Bulletin Number - BP2A - 01

Project	Steamboat I	Base Village Re	devel	opment		Date 05/26	/2021	
Project Location	Steamboat,	Colorado				Architect's Pro	ject Number 03.7	835.000
Owner/Client	Alterra Mour	ntain Company	/ Eas	t West Partners	S	File 6BL T	his is page 1 of	
То	Saunders Co	onstruction Inc.				Attention B	ryan Sculthorpe	
Address	86 Invernes	s Place North						
City	Englewood					State CO	Zip 80112 Code	
Delivered via:	П	Messenger	П	Hand carried	П	Facsimile		
Denvered via:		Express		Pick-up		E-mail Address		
		Mail		UPS		Website Address	BIM360	
This Bulletin Convey	s to Contractor (Check one of the fo	ollowing	g five choices.):				
Architect's Author		or Changes to the Work as des	cribed	below.				
		mental Instruction				, ,	ntal Instructions form	•)
Architect's Confir This confirms Archi Note: The above the is/are issued in acco	tect's verbal instr ree choices are ea	ructions to (individu ach subject to the fo	al's nar ollowing	me) on (date g terms: The change	e), a: e(s), clarific	s described below. ation(s) and/or confir	mation(s) described b	RCRBI

General: This bulletin addresses clarifications to Gold Walk's door schedules, door hardware, and room numbering for pe

A-DS1.01

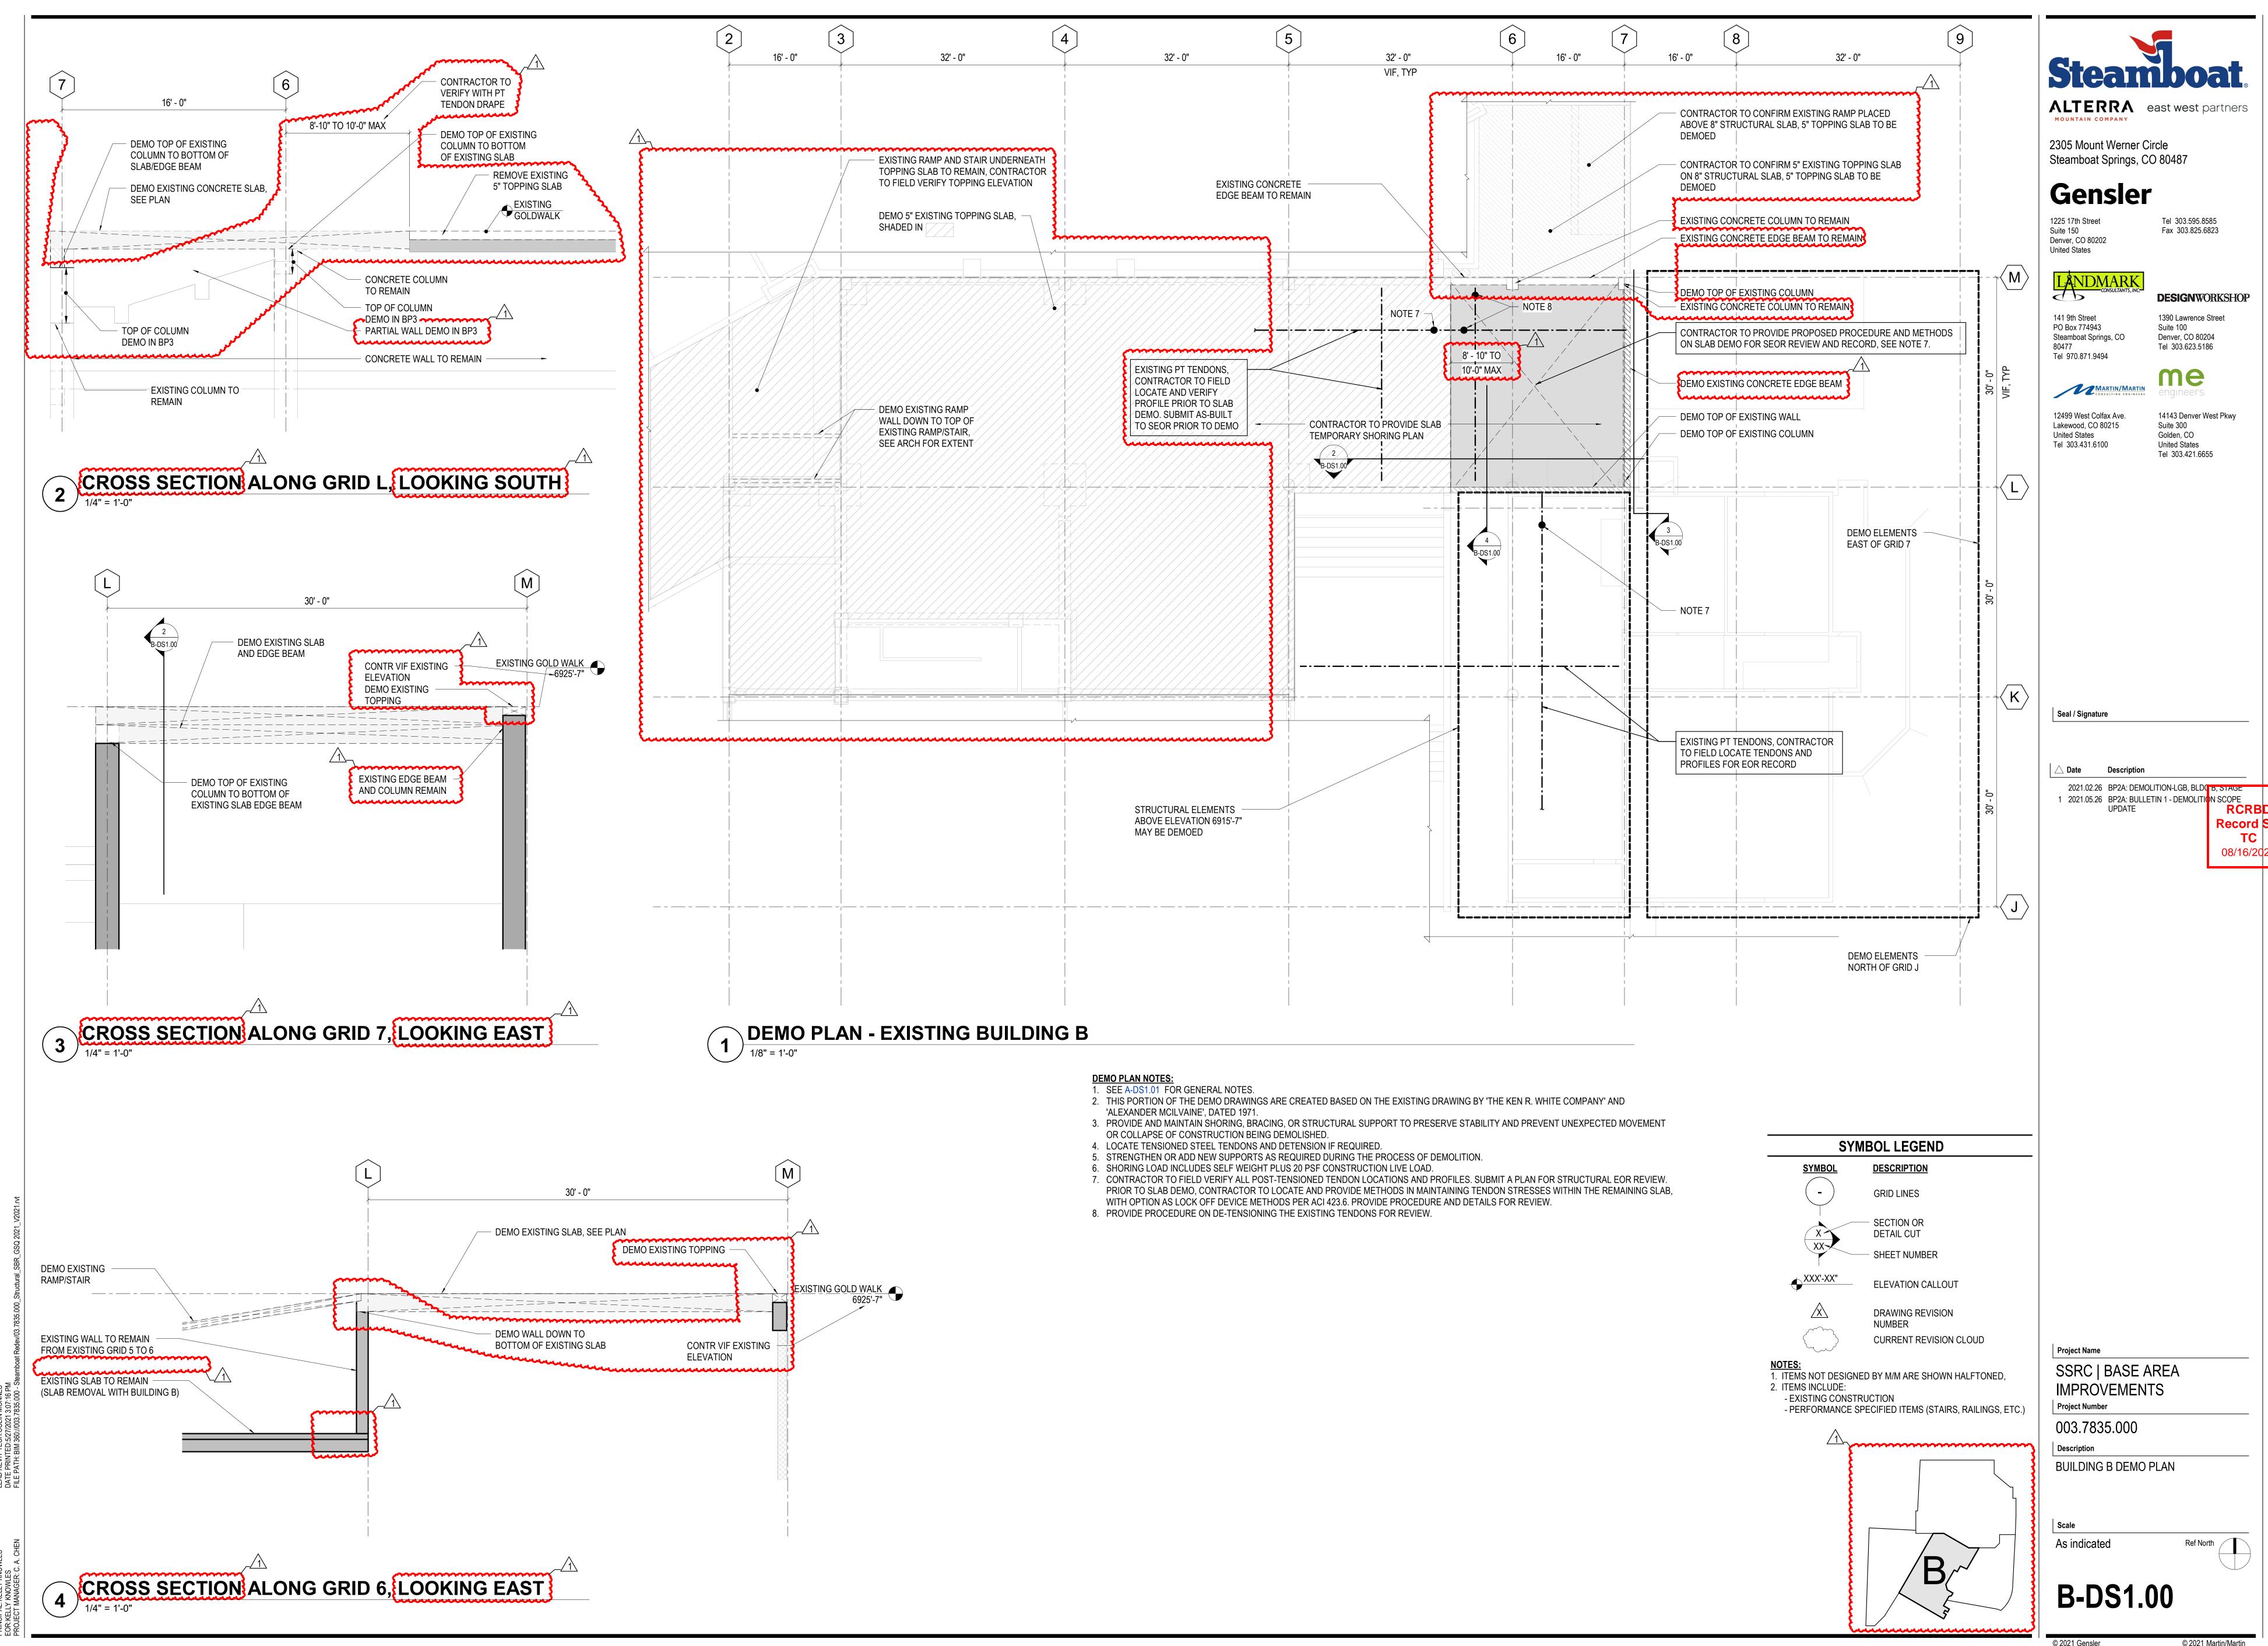
- 1. A-DS1.01 LOWER GONDOLA BUILDING DEMO PLAN
 - a. Plan 1
 - i. 4" topping slab removal note is added at the existing stage.
 - ii. Top of counterweight pit wall elevation is revised.

- iii. Existing slab demo extent at the OSP is clarified.
 - iv. Existing wall demo note is added.
 - b. Detail 2 Top of counterweight pit wall elevation is revised.

- c. Detail 3 Existing composite slab demo clarification detail is added.
 - d. Detail 4 Existing concrete slab demo clarification detail is added.
- 2. B-DS1.00 BUILDING B DEMO PLAN

A-D4.100

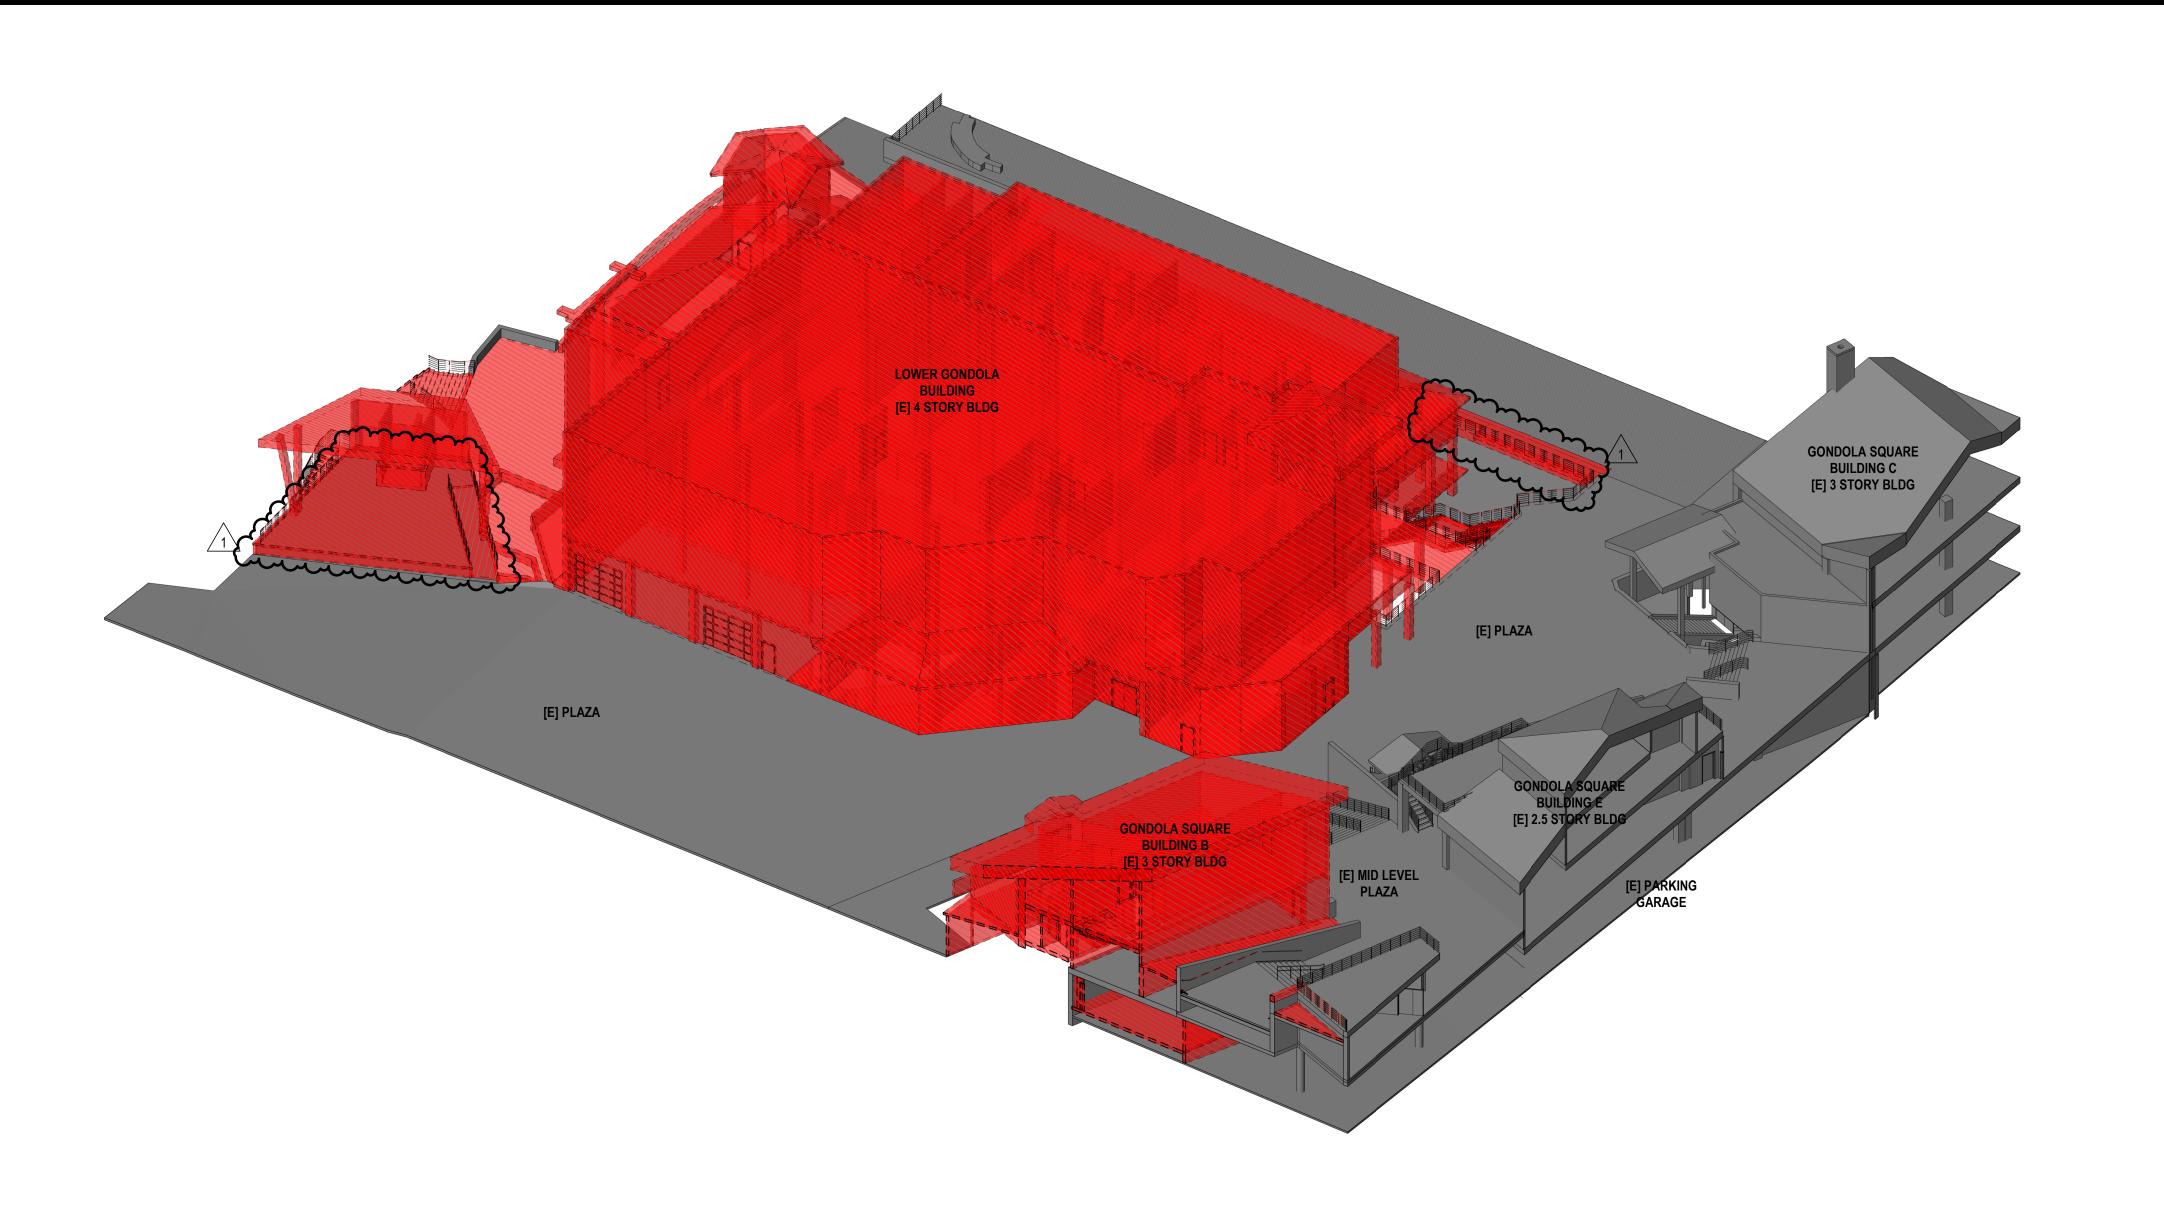
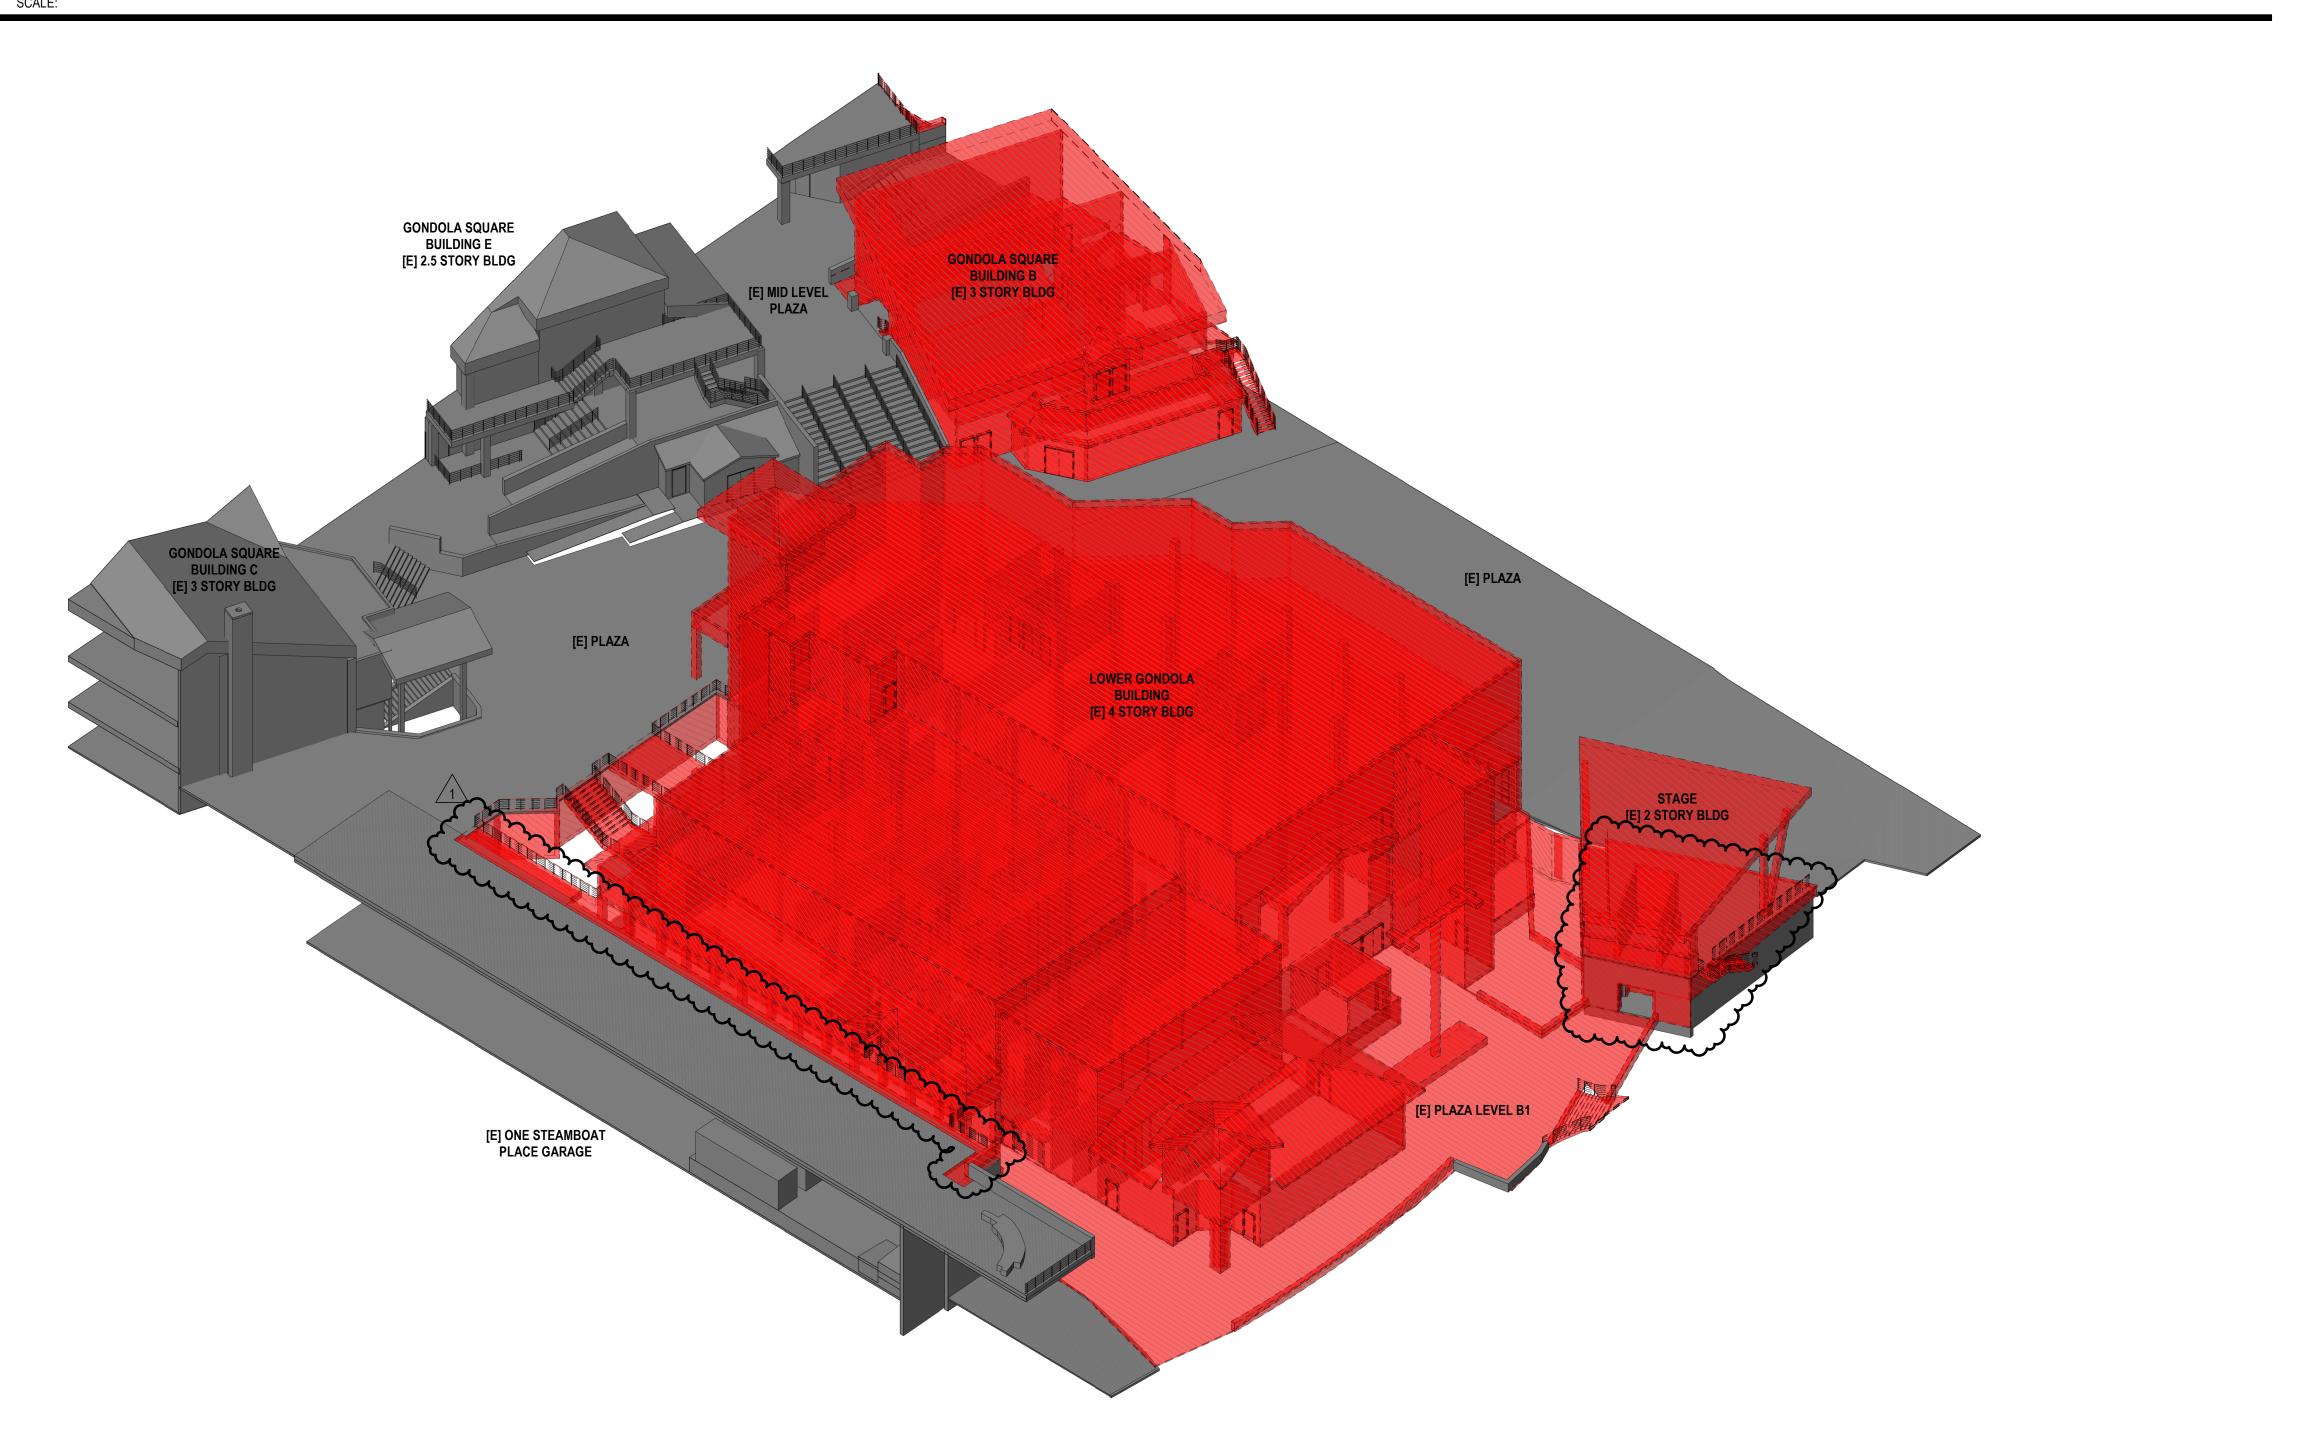
- c. Added Demolition Detail 03, 04 and 05
 - d. Sheet notes Added note #58 and 69
- 5. A-D4.100 DEMOLTION AXONOMETRIC LOWER GONDOLA BUILDING & STAGE
 - a. Axon NW Revised indicated scope

- b. Axon SW Revised indicated scope
- 6. B-D1.101 DEMOLITION PLANS BUILDING B LEVEL 01
 - a. 01 DEMOLITION PLAN LEVEL 01 B BUILDING Portion of garage wall shown as removed
